Subject: N202294740-02 - Service Update
Software Update for Multiple Modules
Revised Service Procedure

Models: 2020 Cadillac CT5

N202294740 Software Update for Multiple Modules

Revision: 02

5618445

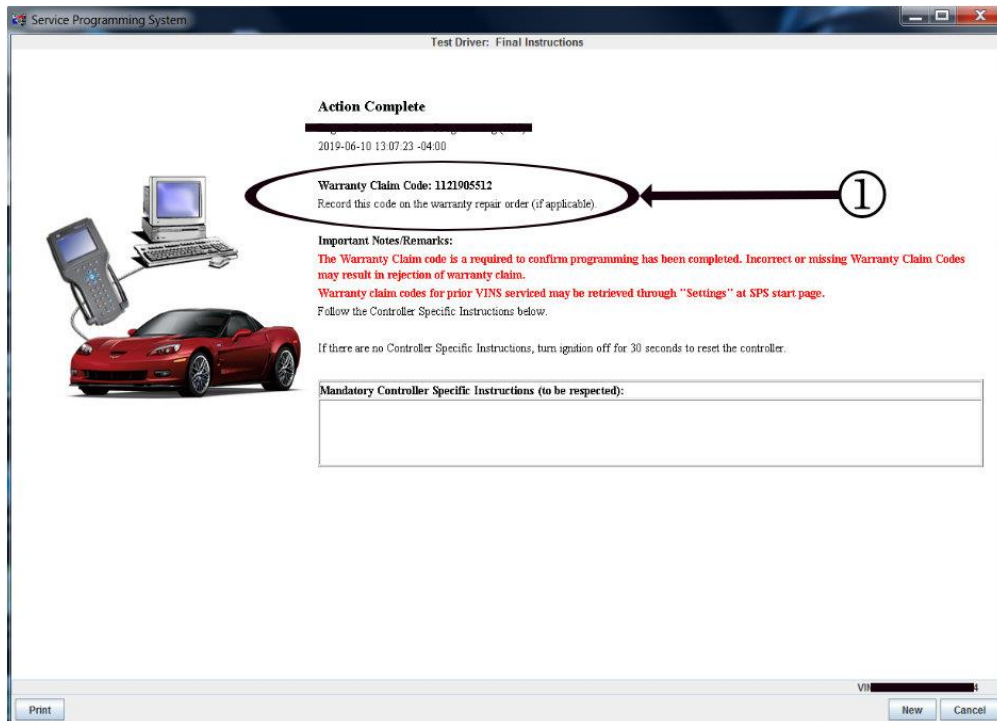
1. Reprogram the instrument panel cluster control module:
 - 1.1. Select P16 Instrument Panel Cluster Control Module under "Select Controller" and Programming" under "Select Function/ Sequence", click next and follow on screen instructions.
 - 1.2. After programming has completed, Select P16 Instrument Panel Cluster Control Module under "Select Controller" and Graphics Programming under "Select Function/ Sequence", click next and follow on screen instructions.
2. Reprogram the sequential multiple modules through SPS/Techline Connect (SPS and Techline Connect screens shown) by selecting "ZFA - Multimodule Coordinated Sequence-Bulletin N202294740" on the select controller screen as shown. Select "Next" and follow all onscreen instructions.

5431209

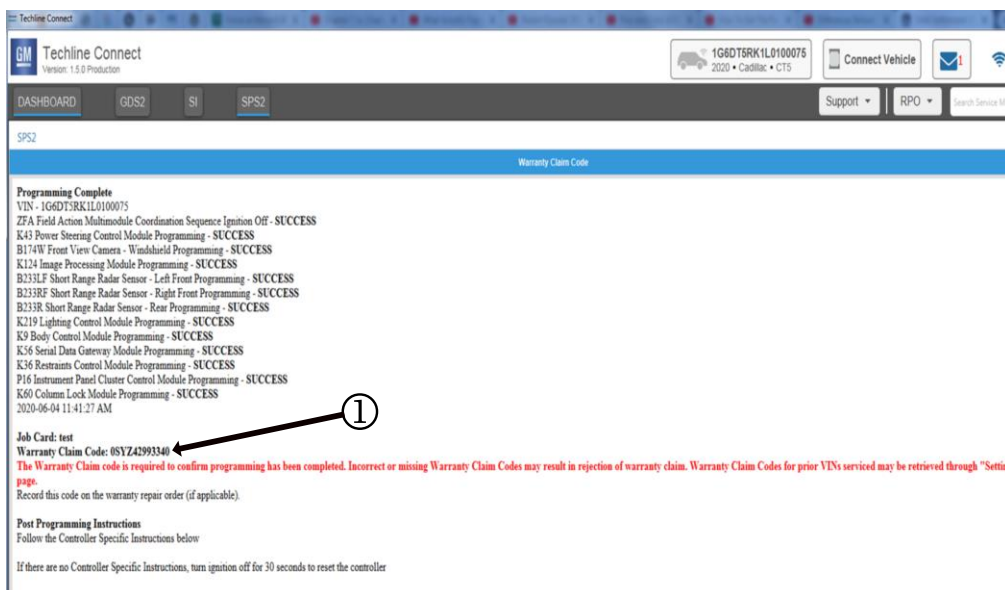
Important: To avoid warranty transaction rejections, you **MUST** record the warranty claim code provided on the Warranty Claim Code (WCC) screen shown above on the job card. Refer to callout 1 above for the location of the WCC on the screen.

- Record SPS Warranty Claim Code on job card for warranty transaction submission.
